# ADDENDUM NO. 2

**August 3, 2026**

## **MERRILLVILLE HS CULINARY AND MEETING AREA RENOVATIONS AND MERRILLVILLE CSC CENTRAL OFFICE ADDITION AND RENOVATION PROJECT**

**Addendum Two (AD.02)** to the drawings and specifications prepared by Gibraltar Design for **Merrillville HS Culinary and Meeting Area Renovations and Merrillville CSC Central Office Addition and Renovation** for Merrillville Community School Corporation, Merrillville, Indiana.

DRAWING  
UNIT "T" ARCHITECTURAL ROOF  
PLAN

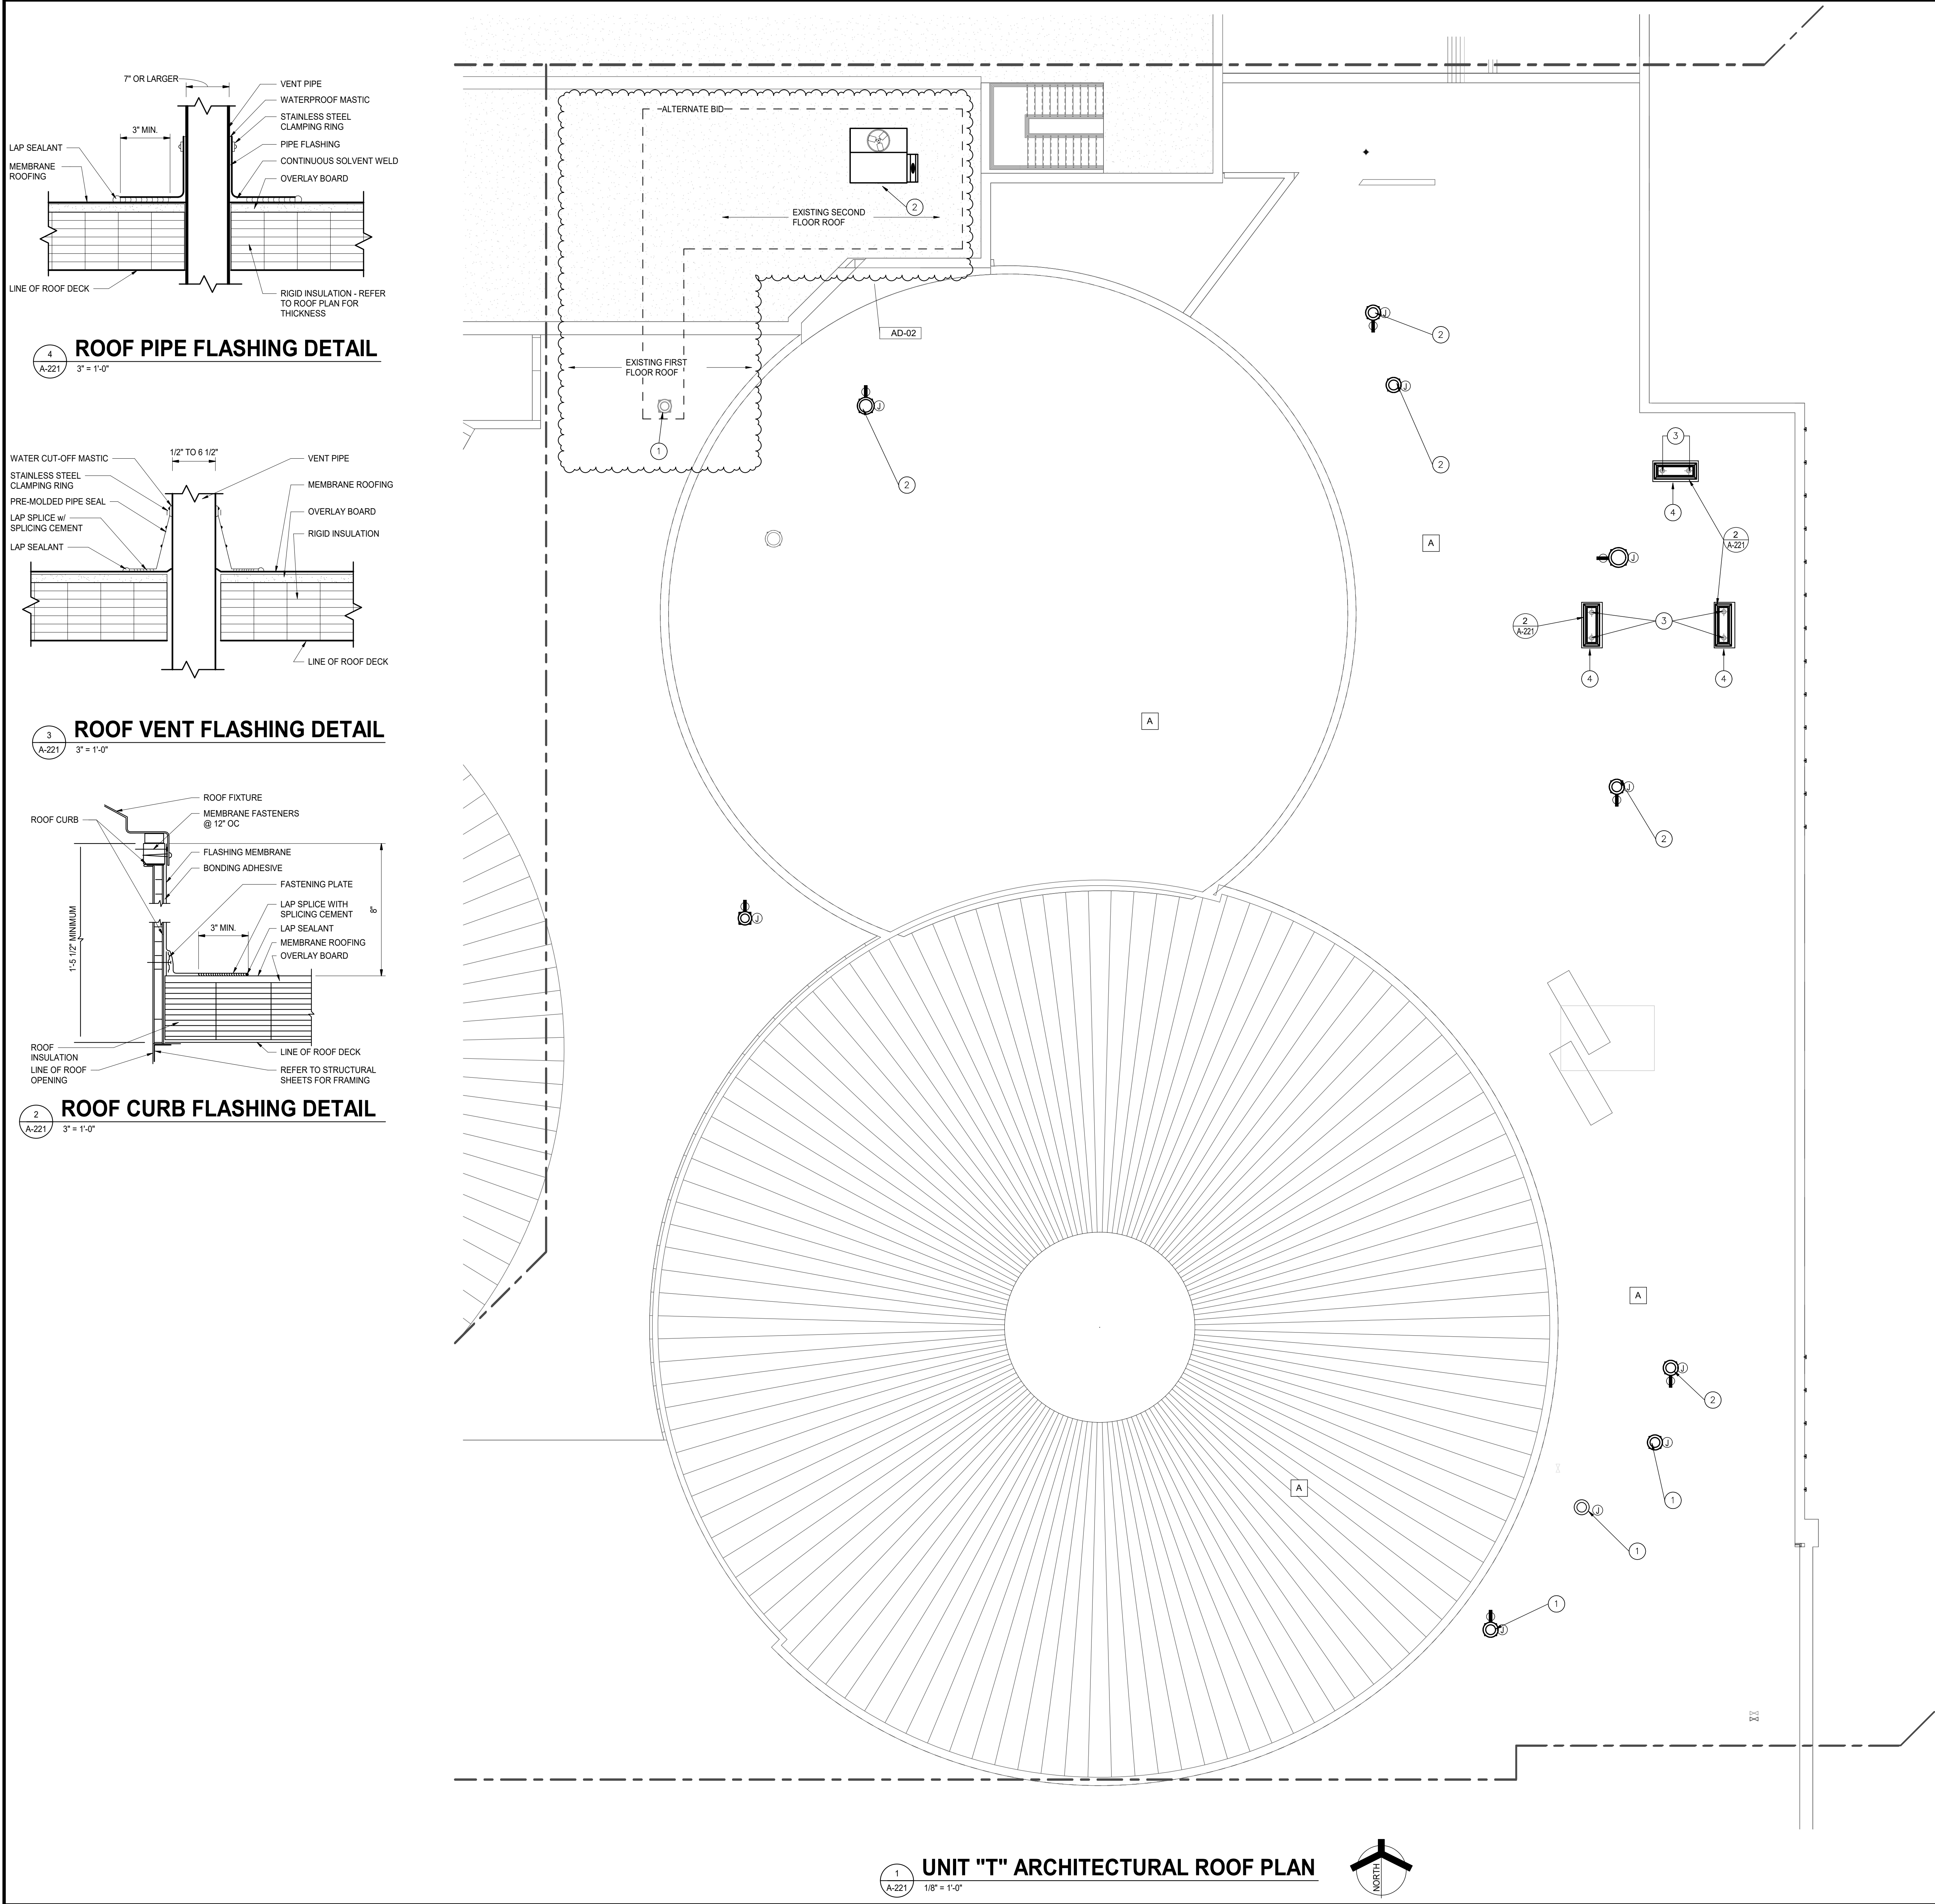
- A. Refer to revised, full-size drawing, included in this Addendum, for revisions.
  - 1. Added locations of mechanical units for Room T-126 and Elec T-127, both units being part of a single alternate bid.

DRAWING  
UNIT "T" MECHANICAL DUCTWORK FIRST FLOOR PLAN

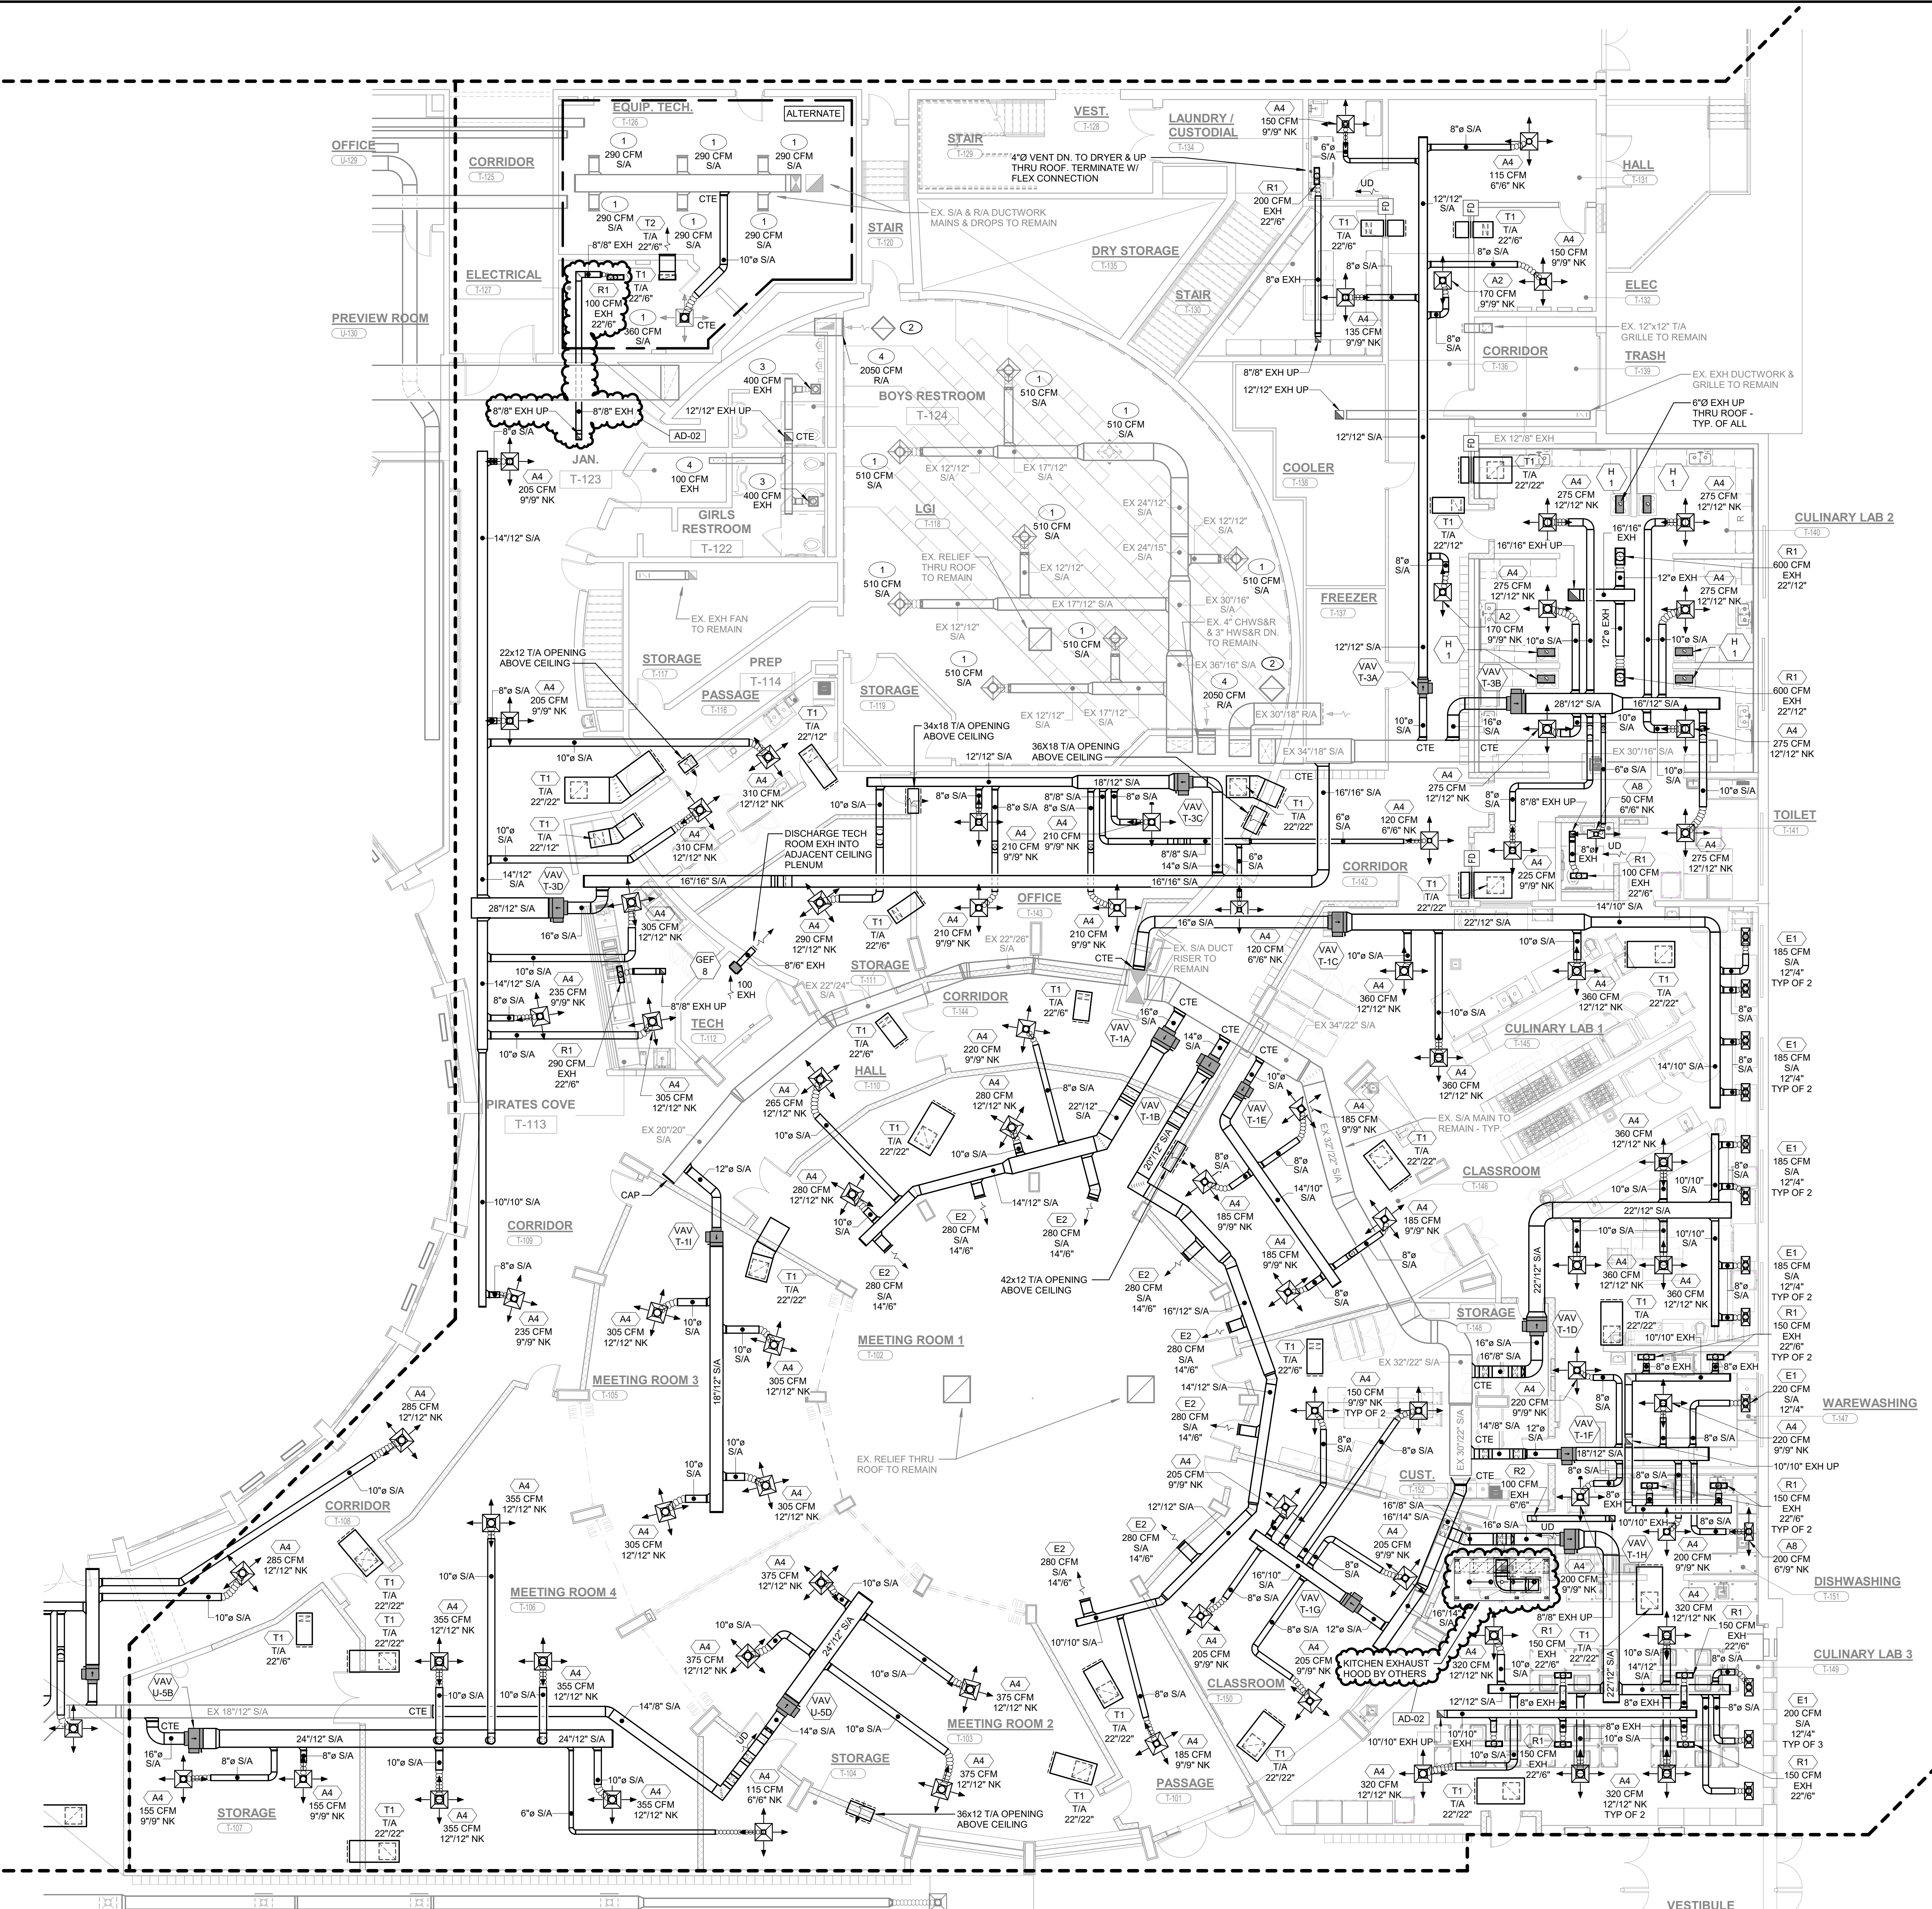
- A. Refer to revised, full-size drawing, included in this Addendum, for revisions.
  - 1. Revised exhaust ductwork for Electrical – T-127.
  - 2. Added hood note in Culinary Lab 3.

DRAWING  
**UNIT "T" MECHANICAL ROOF PLAN**

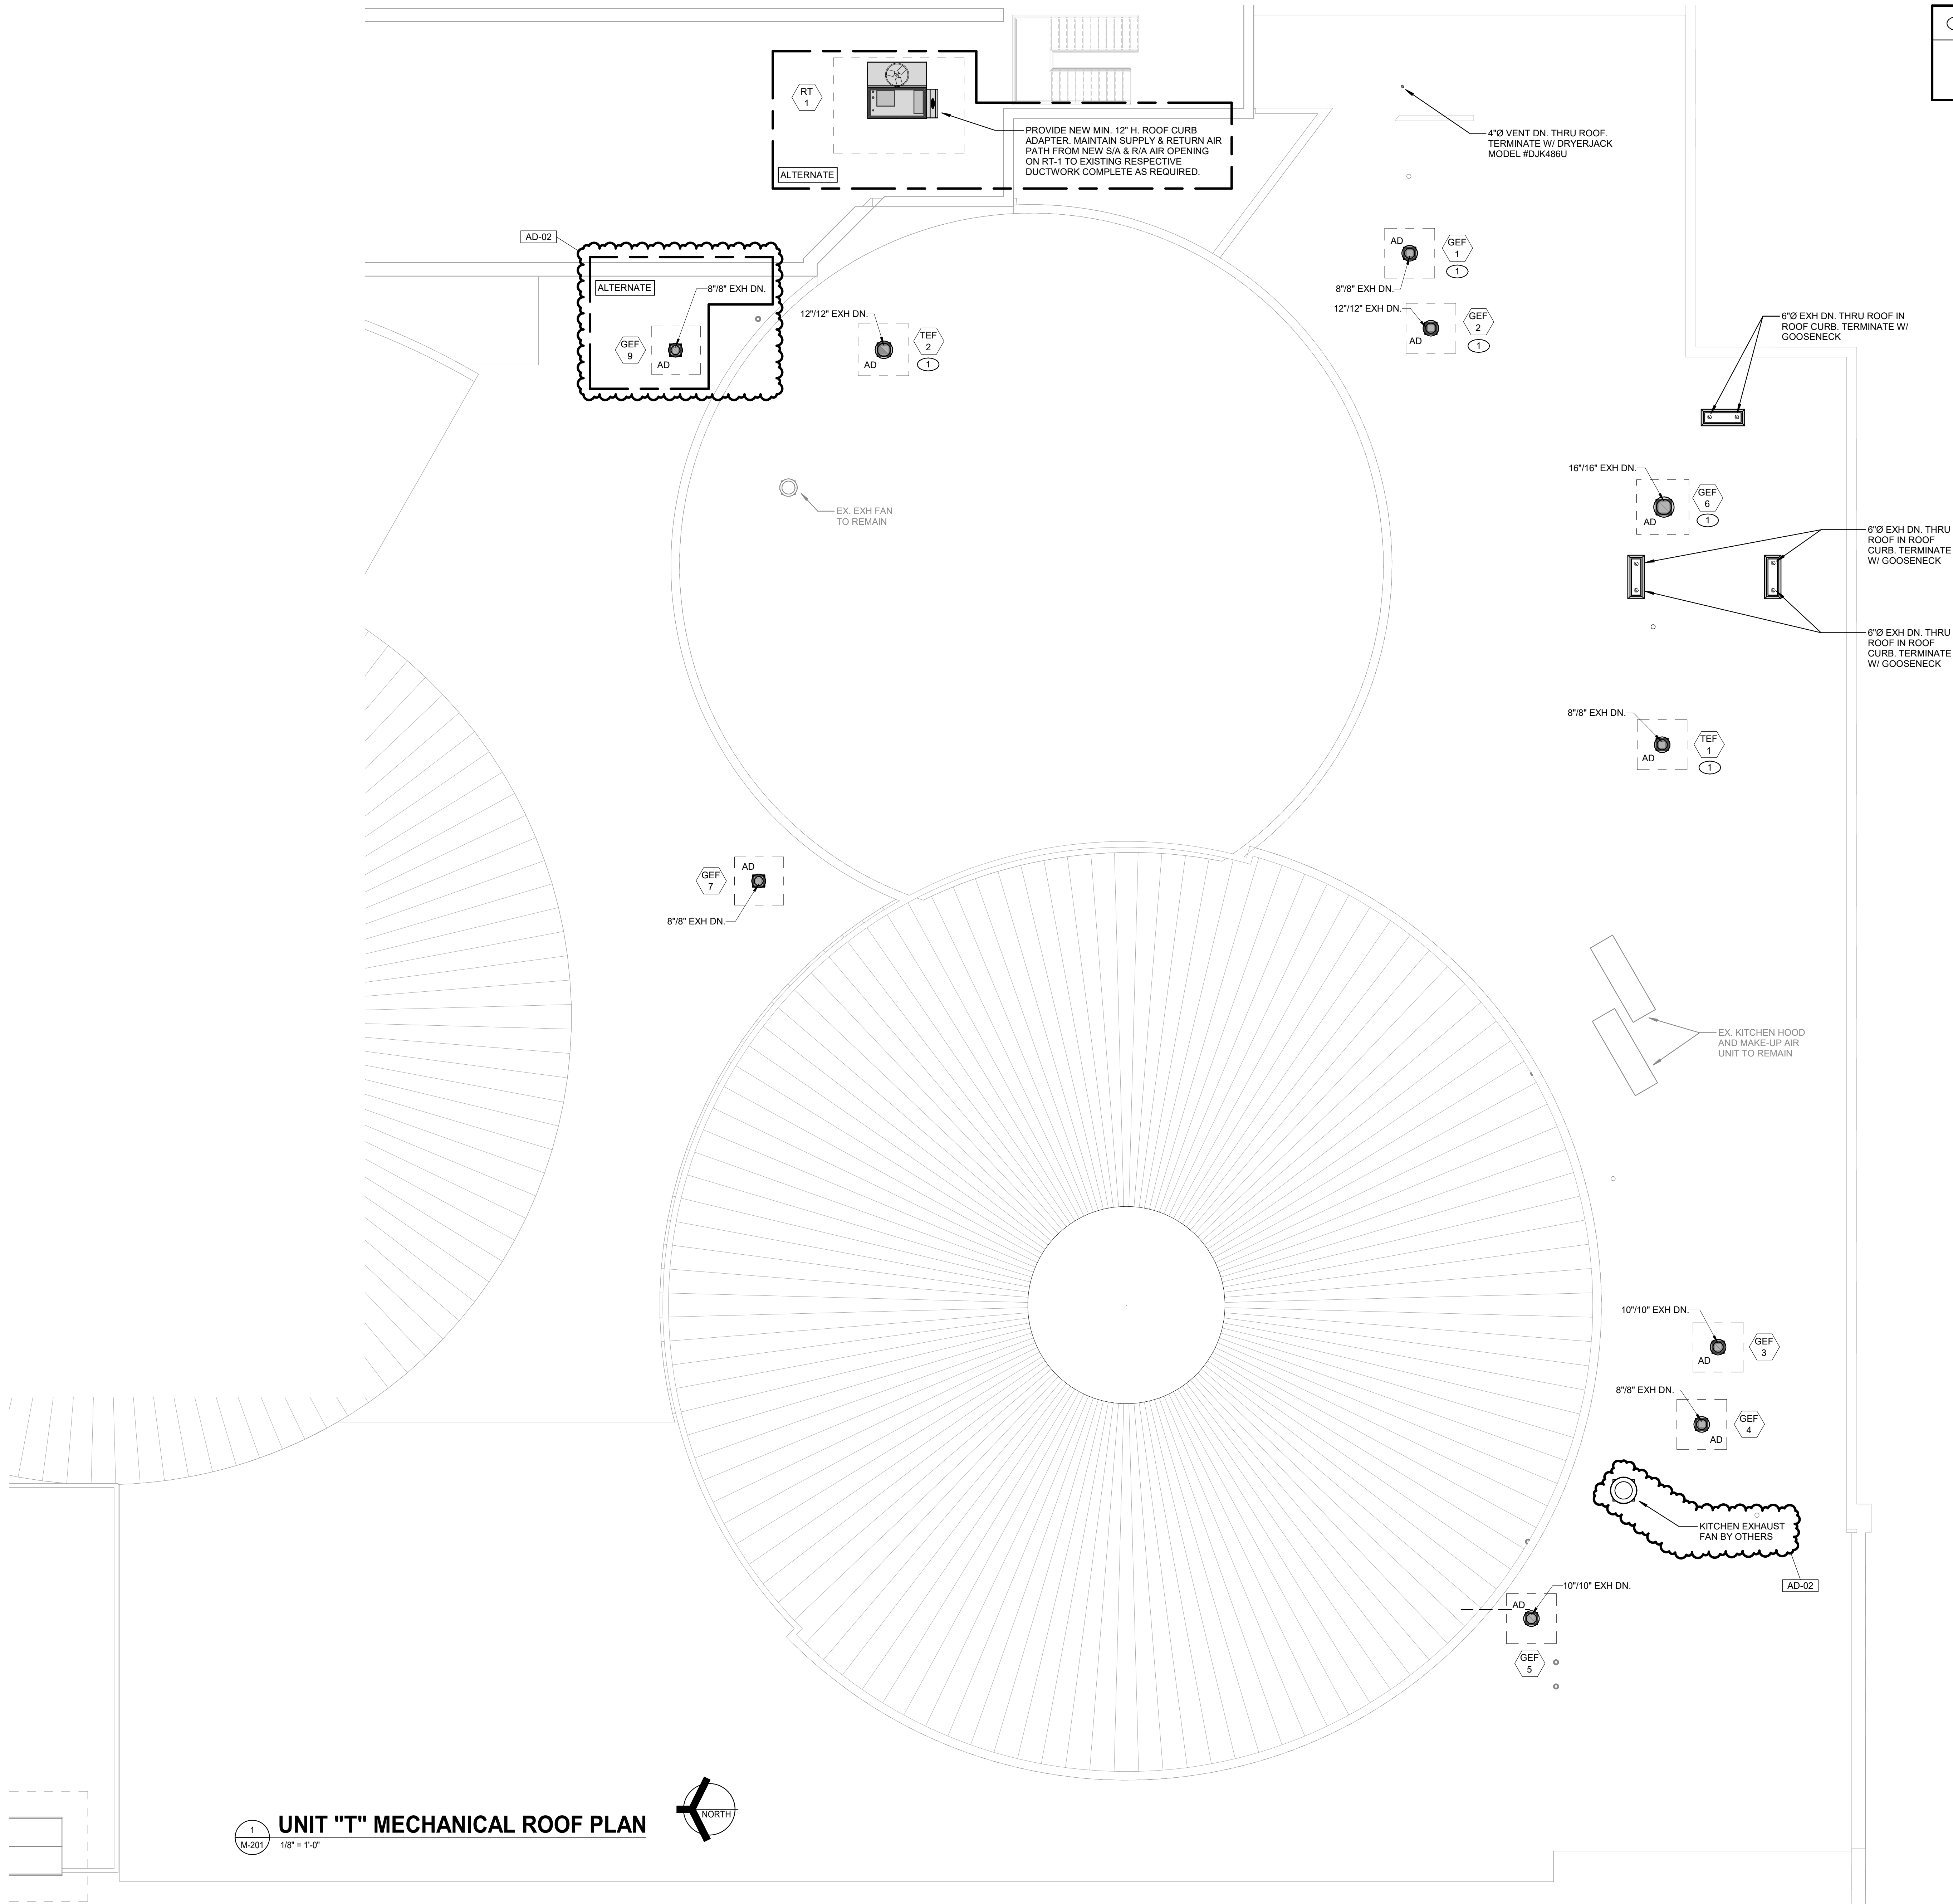
- A. Refer to revised, full-size drawing, included in this Addendum, for revisions.
  - 1. Added note for hood exhaust fan.
